CITY OF WESTMINSTER			
PLANNING APPLICATIONS COMMITTEE	Date 31 January 2017	Classification For General Release	
Report of Director of Planning		Ward(s) involved West End	
Subject of Report	8 Chesterfield Hill, London, W1J 5BW,		
Proposal	Excavation to lower existing lower ground floor by 1 metre and erection of building over lower ground, ground, first - third floors and set-back mansard roof to accommodate five flats (Class C3), creation of terrace at fourth floor level and installation of plant and sedum roof at roof level.		
Agent	Jon Dingle		
On behalf of	Wellingtons Developments Ltd		
Registered Number	16/09976/FULL	Date amended/ completed	26 October 2106
Date Application Received	14 October 2016		
Historic Building Grade	Unlisted		
Conservation Area	Mayfair

Proposal: Excavation to lower existing lower ground floor by 1 metre and erection of building over lower ground, ground, first - third floors and set-back mansard roof to accommodate five flats (Class C3), creation of terrace at fourth floor level and installation of plant and sedum roof at roof level.

Reference: 16/09976/FULL

Elevation of proposed scheme (ref: 16/09976/FULL) and No.7 Chesterfield Hill.

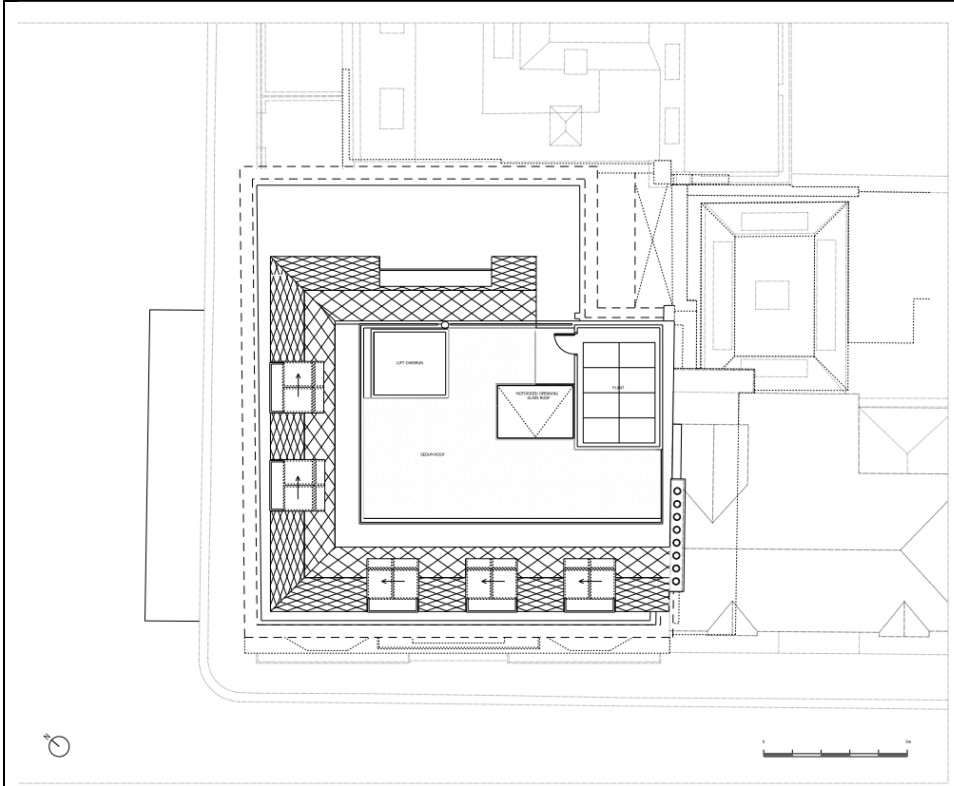
The height and bulk of the proposed building would be one storey greater than previously approved. Objections have been received on the grounds that the mansard would not be in-keeping with the character of the area, however there are a variety of building heights in the vicinity- although notably there are no other buildings along Farm Street of this height. The detailed design of the mansard roof is such that the increased height would be set back from the facades and would not appear obtrusive or out of character. Furthermore, the building would still be of an appropriate scale in terms of its position in the hierarchy of streets, particularly given its corner plot location. Given the relationship with the adjoining property 7 Chesterfield Hill it is considered appropriate that there is no mansard set back to the south side of the site.

The proposed red-brick and Portland stone facades would be typical for building materials found in the area, and the carefully detailed windows including canted bays to Chesterfield Hill, add richness to the overall design. At roof level, the mansard would be clad with dark-grey perforated grey aluminium cladding with recessed bronze coloured windows. Windows to the north and east elevations would have recessed limestone detailing and bronze coloured metal ballustrades.

The design, and in particular the height, of the building is suitable for its location and it correctly addresses the scale of Chesterfield Hill which it faces, rather than the smaller scale of development behind in Farm Street. It is an appropriate response to the local character of the street and surrounding conservation area, and makes use of locally characteristic facing materials, in accordance with Section 7 of the NPPF which requires good design. The development is therefore considered acceptable in design terms and would maintain the character and appearance of the Mayfair Conservation Area and the setting of nearby listed buildings including the grade II listed pub opposite the site in Farm Street. This accords with UDP policies DES 1, DES 4, DES 9 and DES 10, and the city council's 'Development and Demolition in Conservation Areas' supplementary planning guidance.

Drawn: Proposed Layout
 Roof Plan

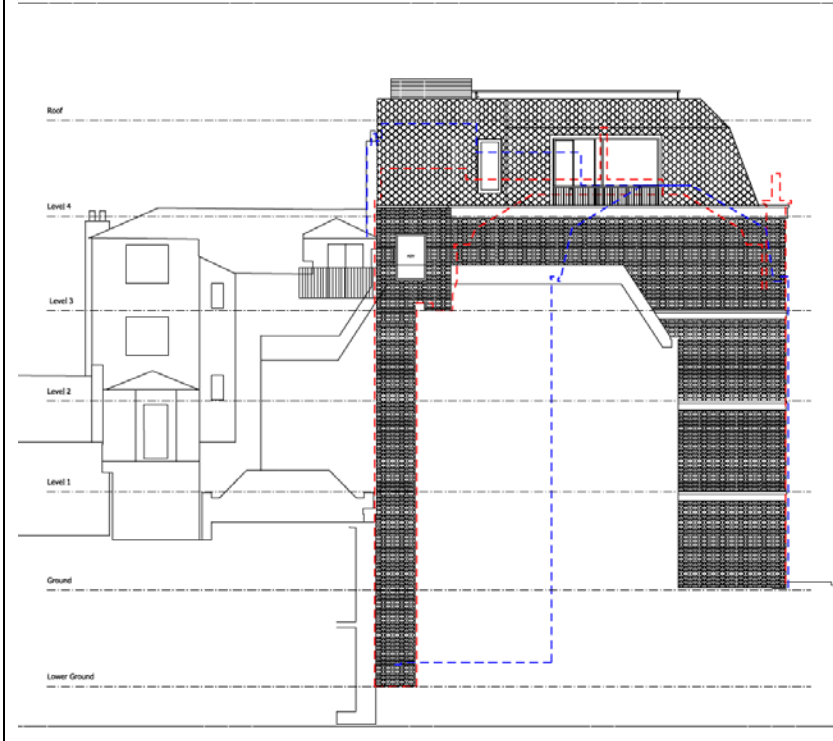
The original submission included a roof terrace to the east side of the roof, however amended plans have been received which remove this element, and which maintain the privacy of neighbouring properties. A condition prevents the use of the flat roof as a terrace in future.

- 12 You must not use the roof of the development for sitting out or for any other purpose. You can however use the roof to escape in an emergency. (C21BA)
